Patent Application:  
X-ray anode and Process for its Manufacture

Applicants : Matthias FRYDA et al. )  
 ) Applications Branch  
 Appln. No. : 10/030,133 )  
 )  
 Filed : January 25, 2002 )  
 )  
 For : X-RAY ANODE AND PROCESS FOR ITS MANUFACTURE

## AMENDMENT UNDER 37 C.F.R. 1.111

Fig. 1

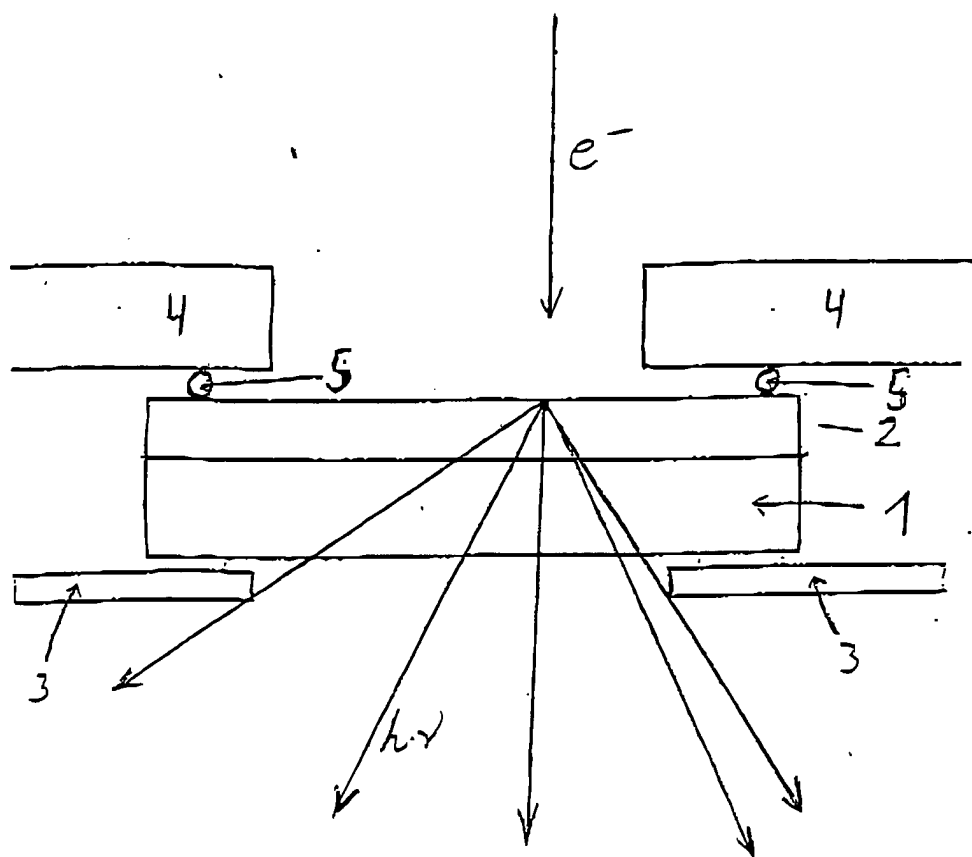
*Please replace the drawing sheet illustrating Fig. 1 with the "Replacement Drawing Sheet" attached to the end of this Amendment:*

In the Replacement Drawing Sheet showing Fig. 1, reference number 5 has replaced reference number 4. Applicant submits that no new matter has been added to the drawings.

Applicant appreciates the courtesy extended by Examiner Irakli Kiknadze in the interview of August 26, 2003. In that interview, Applicant's representative discussed, among other things, amending Fig.1 to show that the sealing washer is represented with reference number 5 and that the specification would be amended consistent with this change.

[0019] A polycrystalline diamond layer 1 with a thickness of 250  $\mu\text{m}$  is deposited on an auxiliary substrate using hot-filament CVD. After removing the auxiliary substrate, a tungsten layer 2 with a thickness of 6  $\mu\text{m}$  is deposited on this diamond layer using physical vapor deposition (PVD). The tungsten layer covers the diamond layer completely. The x-ray source is mounted in the housing (4) 4 of a commercial x-ray microscope by a clamp 3, with sealing washers 4 5 being used to ensure a stable vacuum. The Figure shows this microfocus source in installed condition. X-radiation  $h\nu$  is produced by localized bombardment of the x-ray anode with electrons  $e^-$ . The maximum achievable radiation density is measured with this x-ray anode. If the diamond layer is replaced with a 500  $\mu\text{m}$  thick beryllium layer under otherwise identical conditions, the radiation density of the x-radiation produced is reduced by a factor of 4. With a diamond layer thickness of likewise 500  $\mu\text{m}$ , the radiation density achievable with the x-ray anode according to the invention would be even better, due to the improved heat dissipation.
